ADDENDUM # 2

Concerning the **"PSJA ISD AGRICULTURAL FACILITY PHASE I BID # 18-19-003"** to be opened at 4:00p.m., Thursday, OCTOBER 4, 2018. Please consider the following:

**ADDENDUM NUMBER TWO (2)
TO THE PLANS AND SPECIFICATIONS FOR:**

**PSJA Agricultural Facility – Phase I
PSJA ISD
Bid #
Project No. 16.08**

5 WALL SECTION
3/4" = 1'-0"

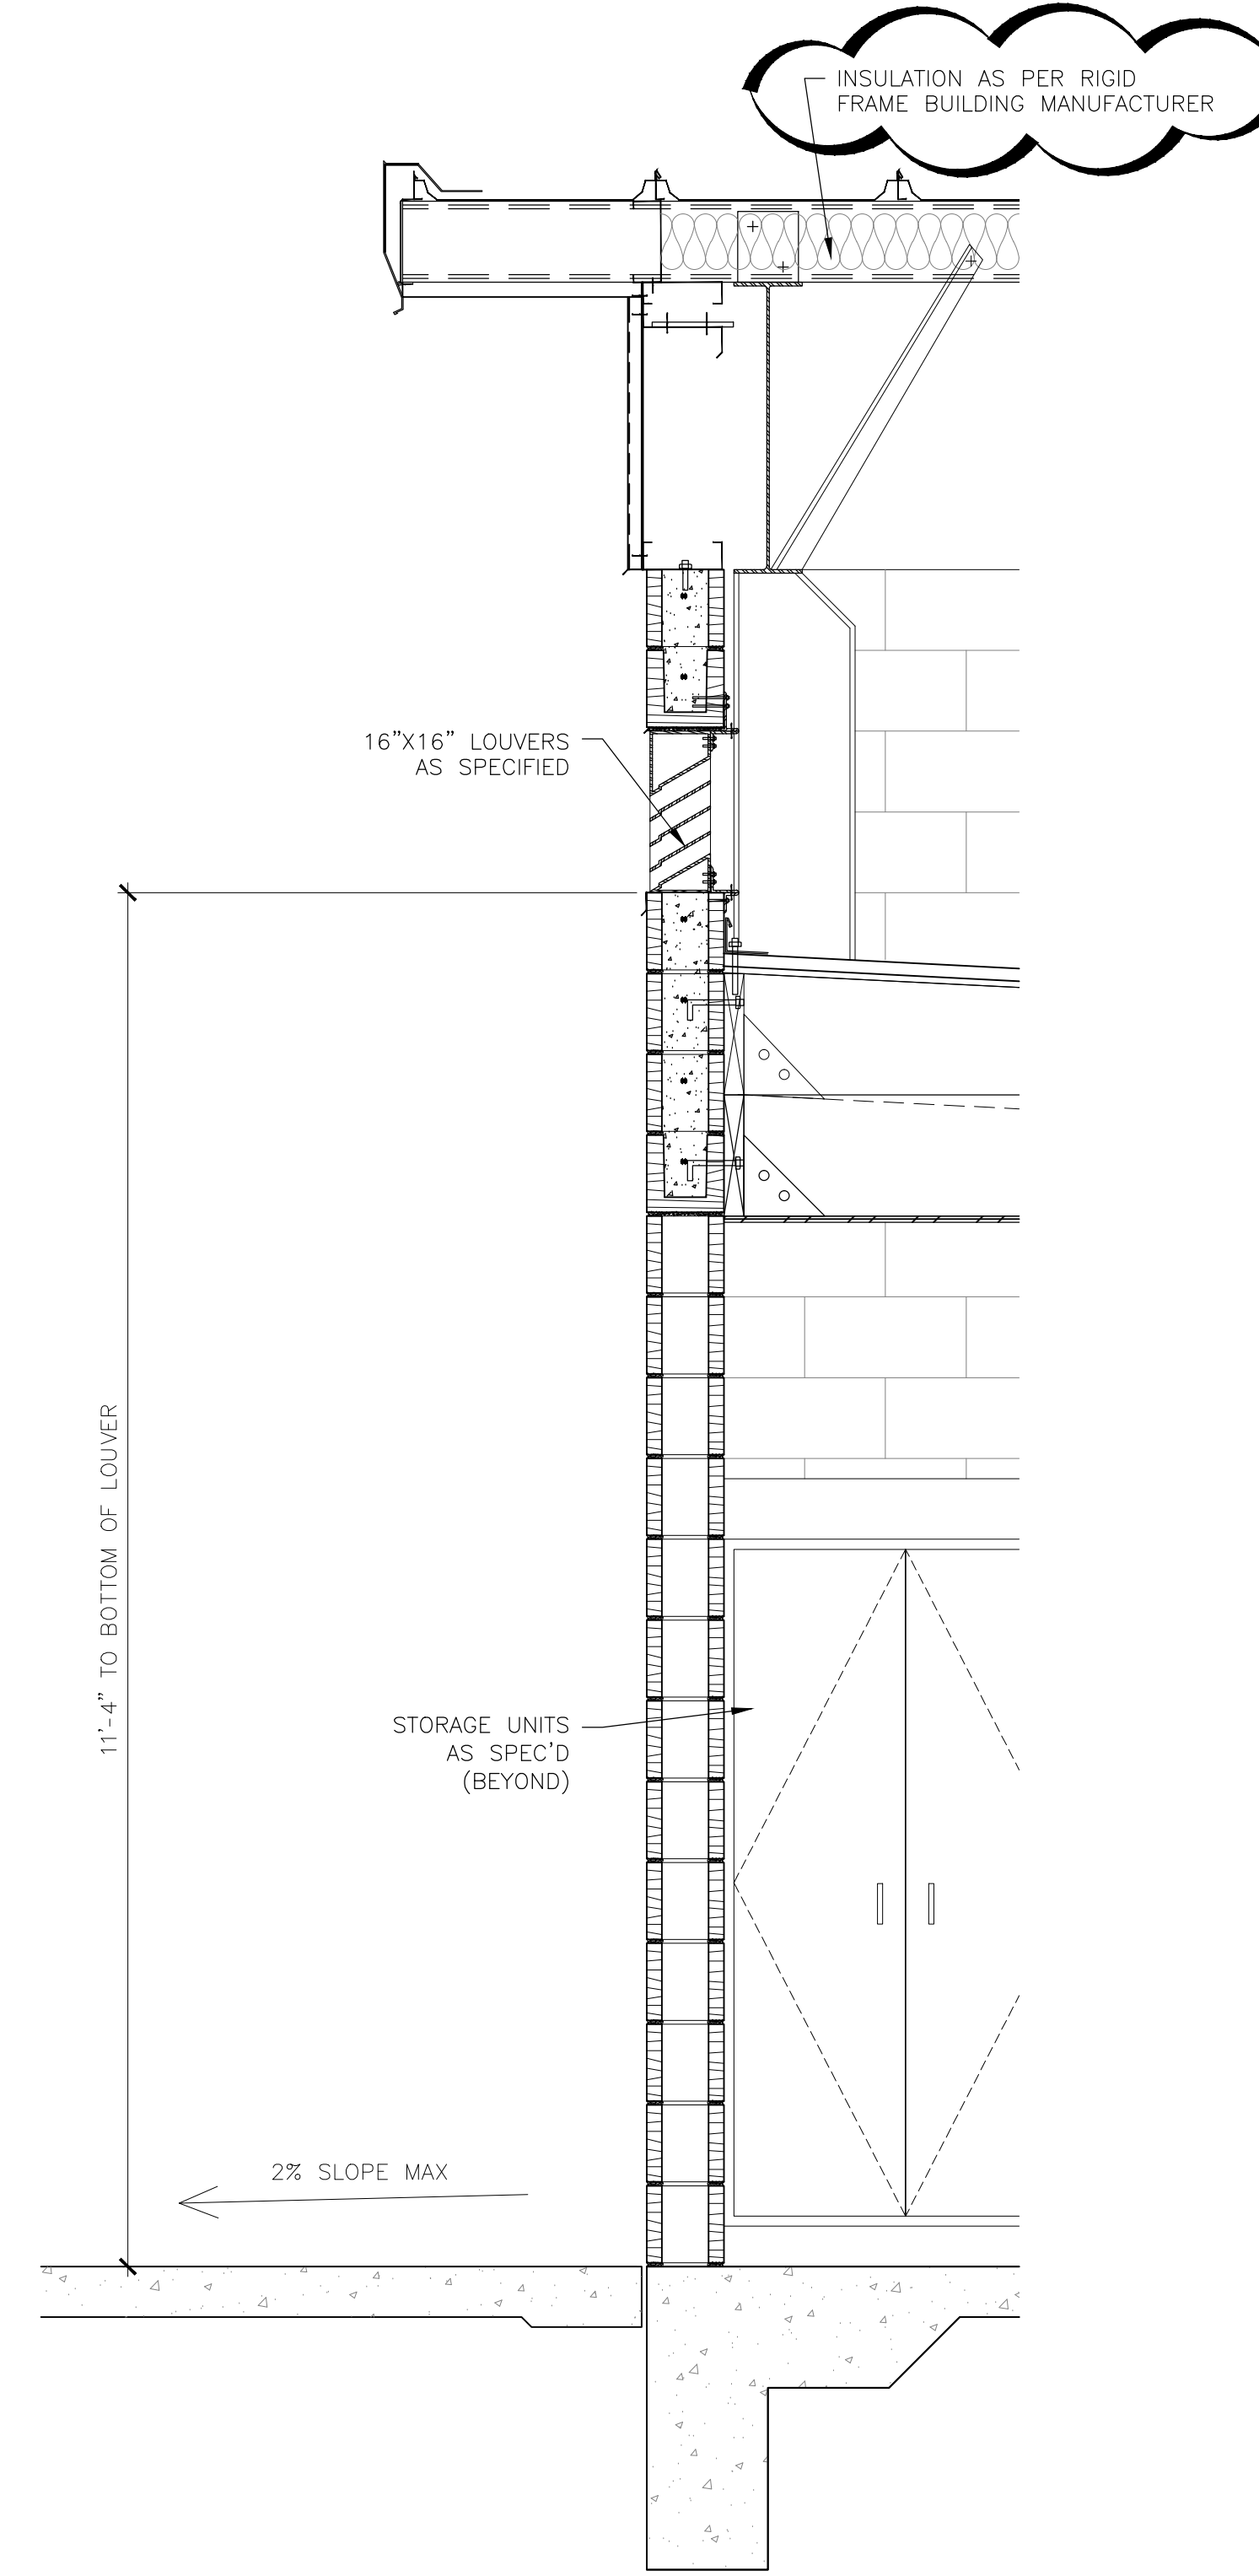
RFI: If the roof panel is not an insulated metal panel, please confirm the use of blanket insulation, thickness, and type (ie..banded system)

RFI: for architect or engineer. Architectural plan sheet A3.02 shows 2x12 wood studs, but on structural sheet S4.2 shows something different. Please verify/clarify.

Refer to reissued sheet A-301 & sheet A-302 for clarification.

Refer to reissued sheets A-301 & A-302 for clarification, detail now reads to refer to Structural.

A-100

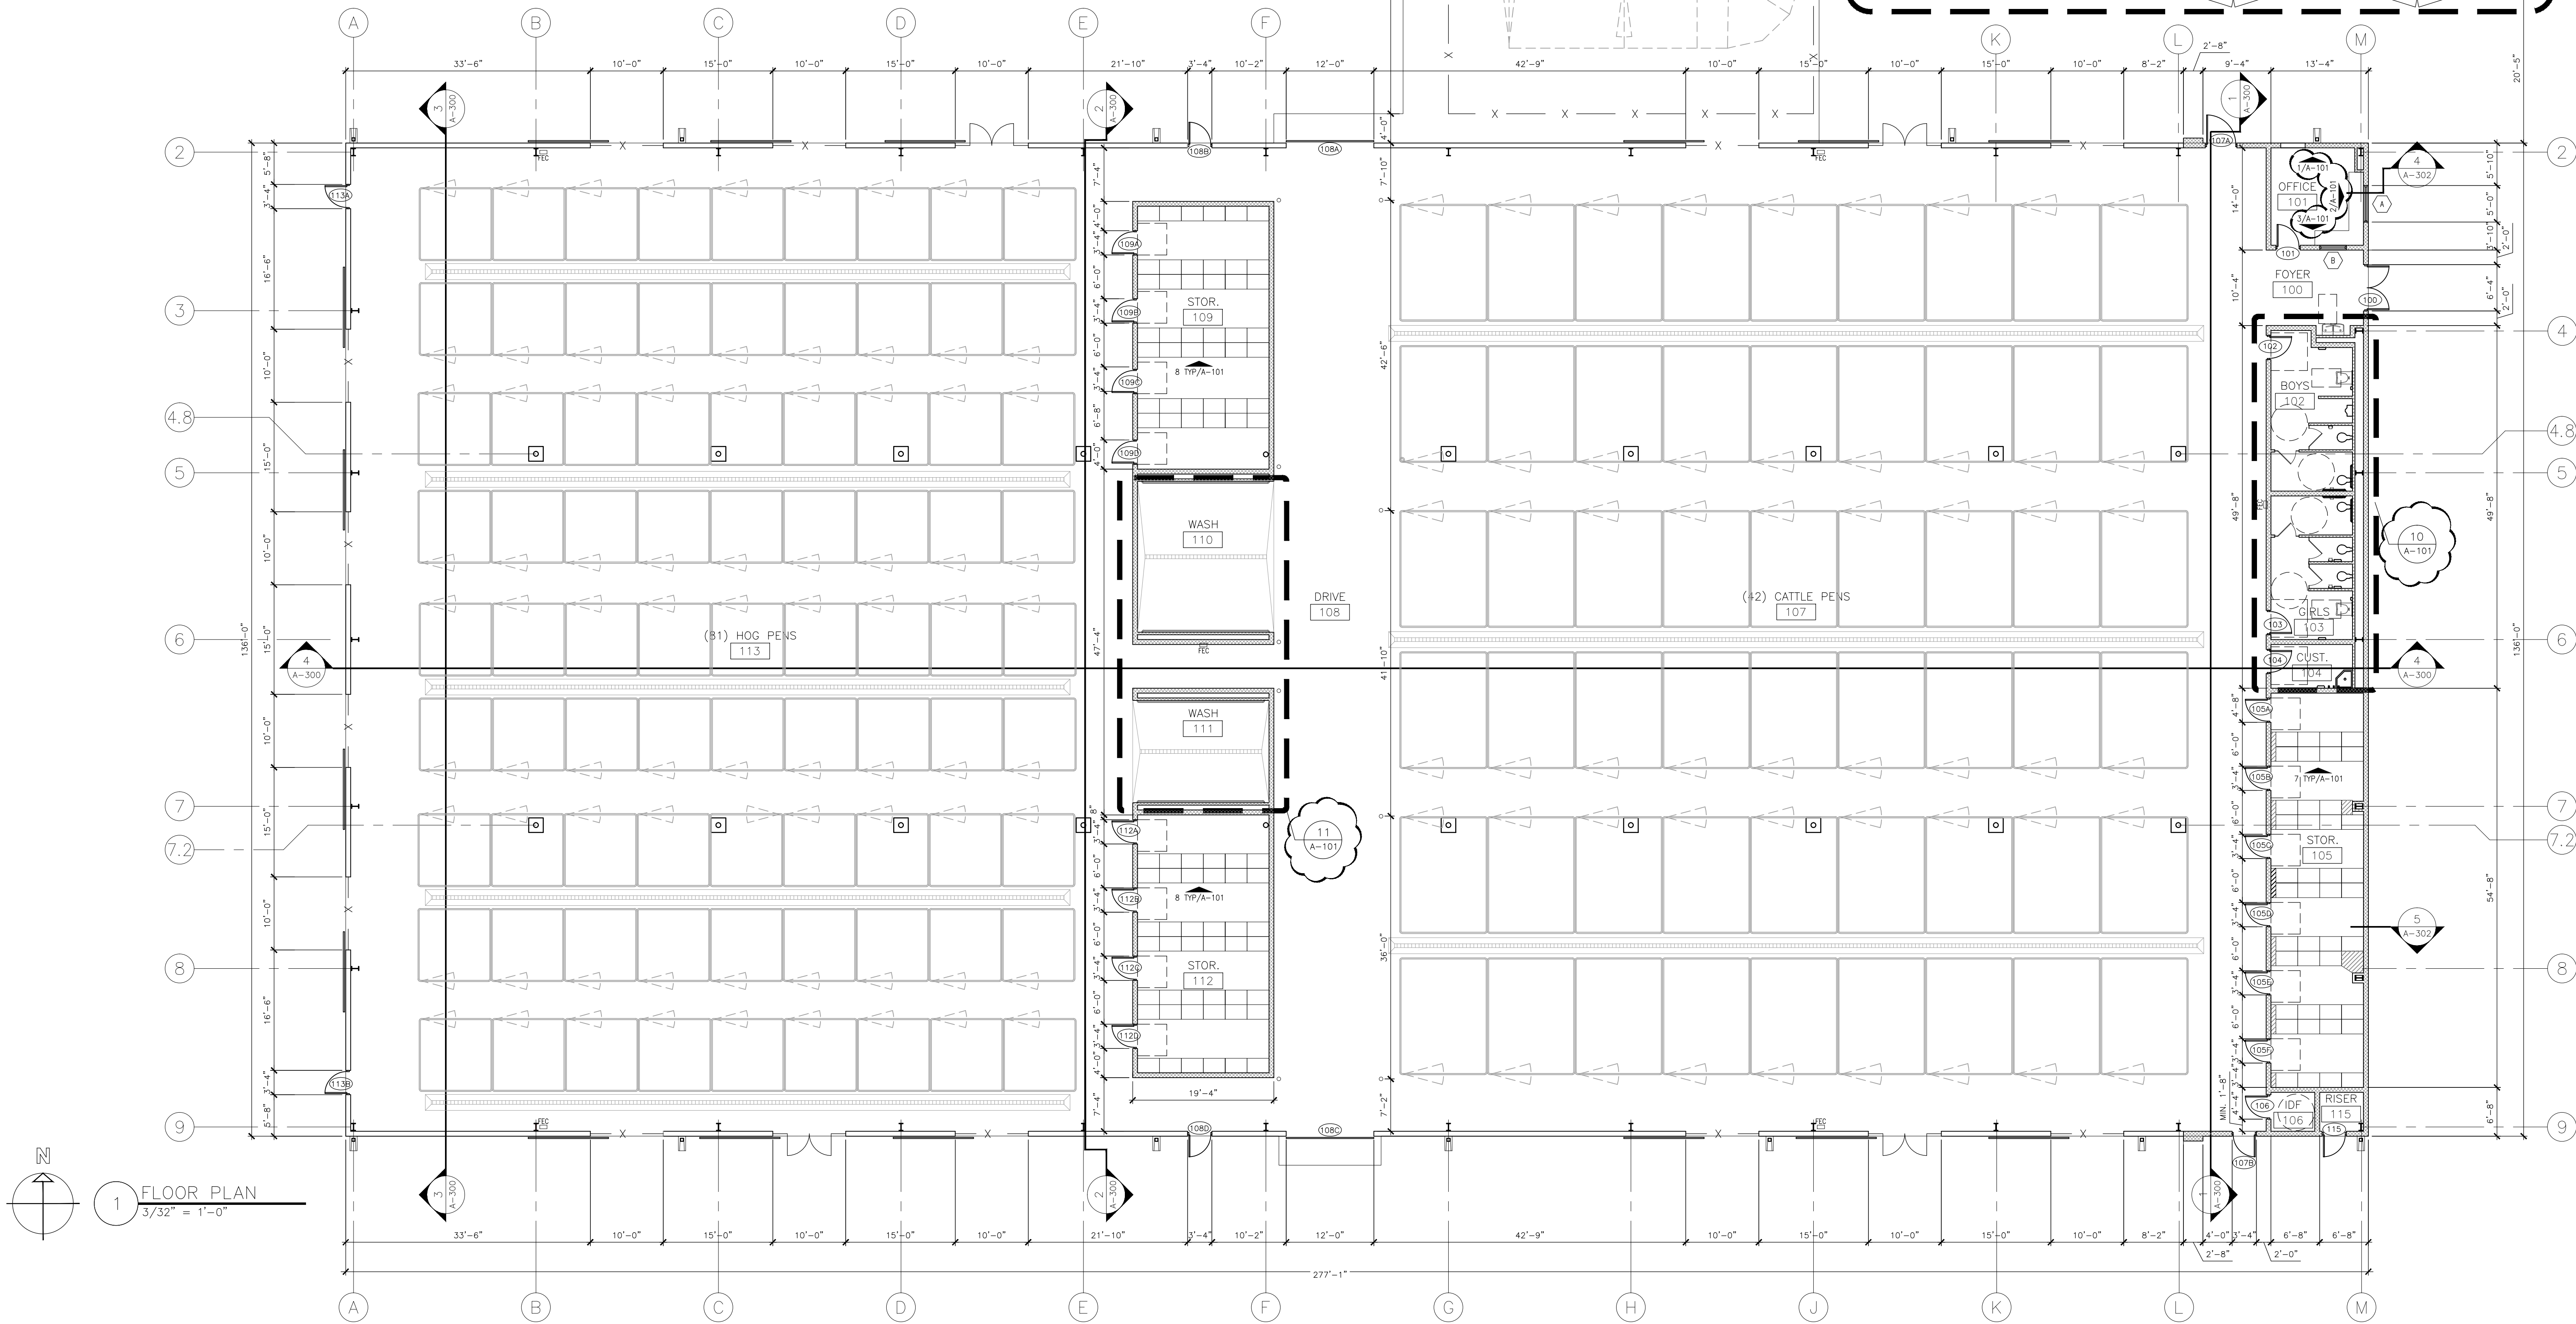
RFI: There are some pages missing. On page (A-100 Floor Plan and base bid) it shows a cut of for page A-102 but there is no page A-102.

Refer to reissued sheet A-100 for clarifications.

A-300

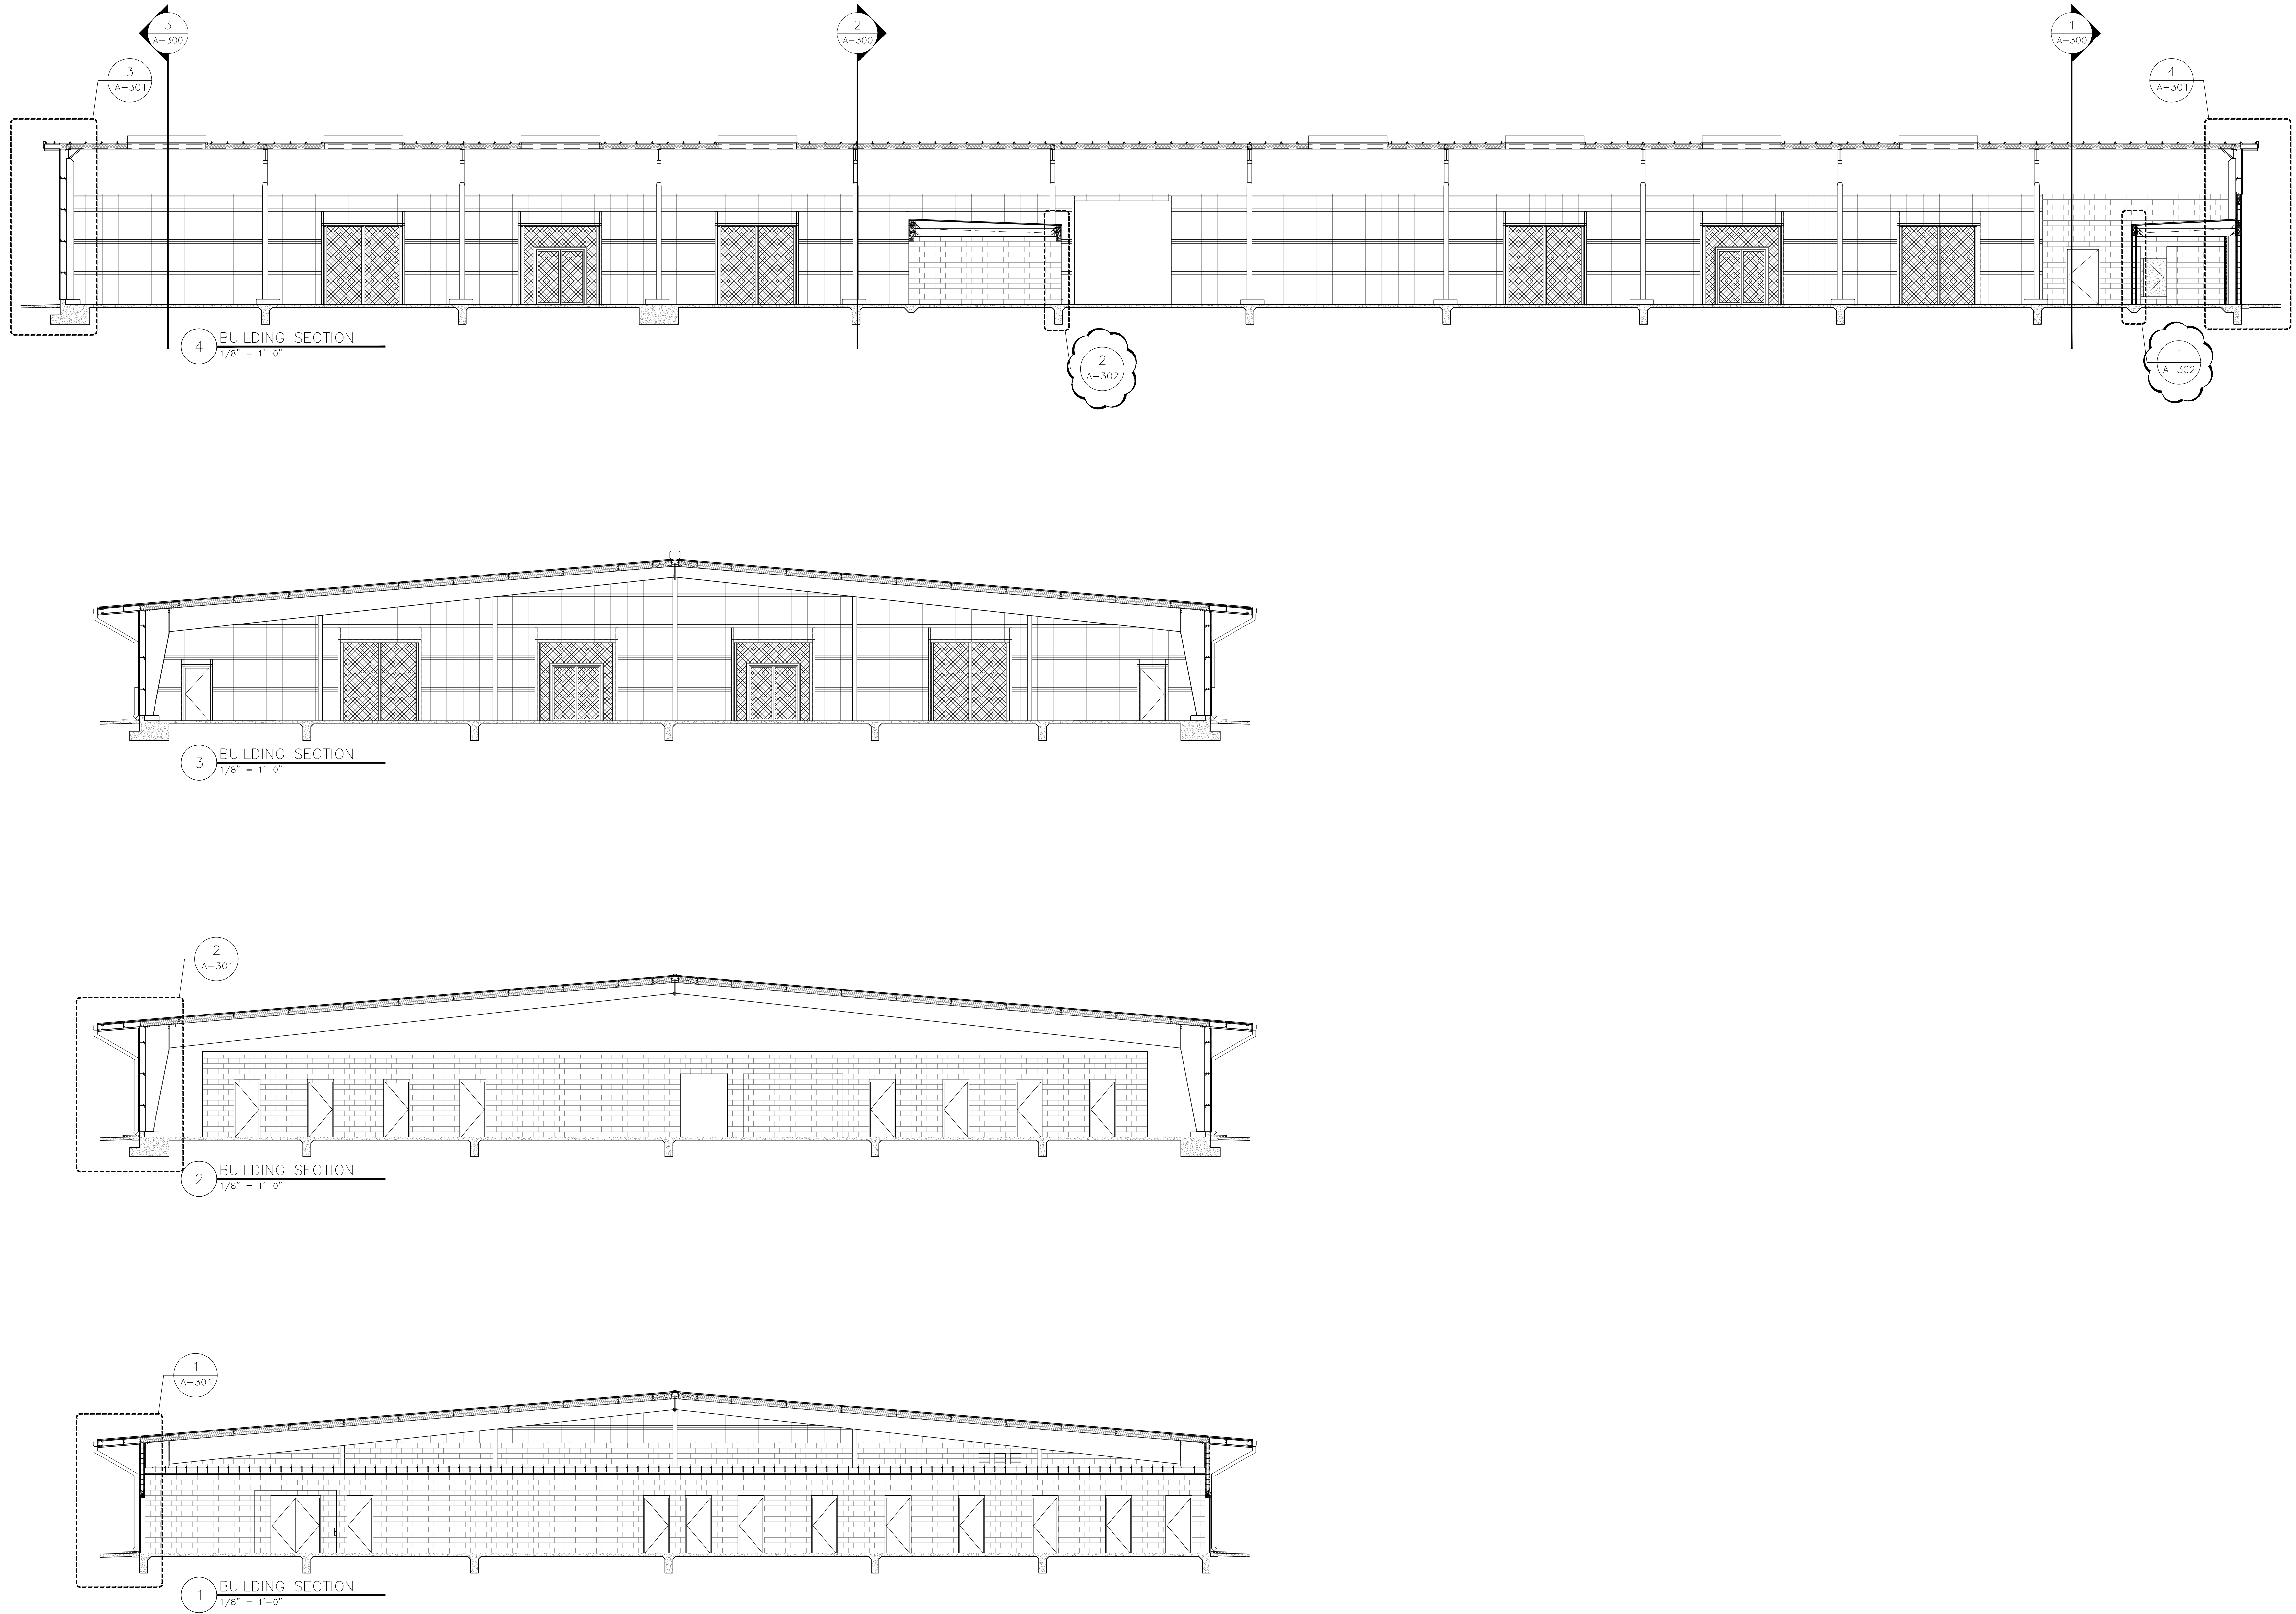
RFI: On page A-300 (building sections) it shows a wall detail on page A-301 detail #6 but when directed to the page it only has 4 details.

Refer to reissued sheet A-300 for clarifications.
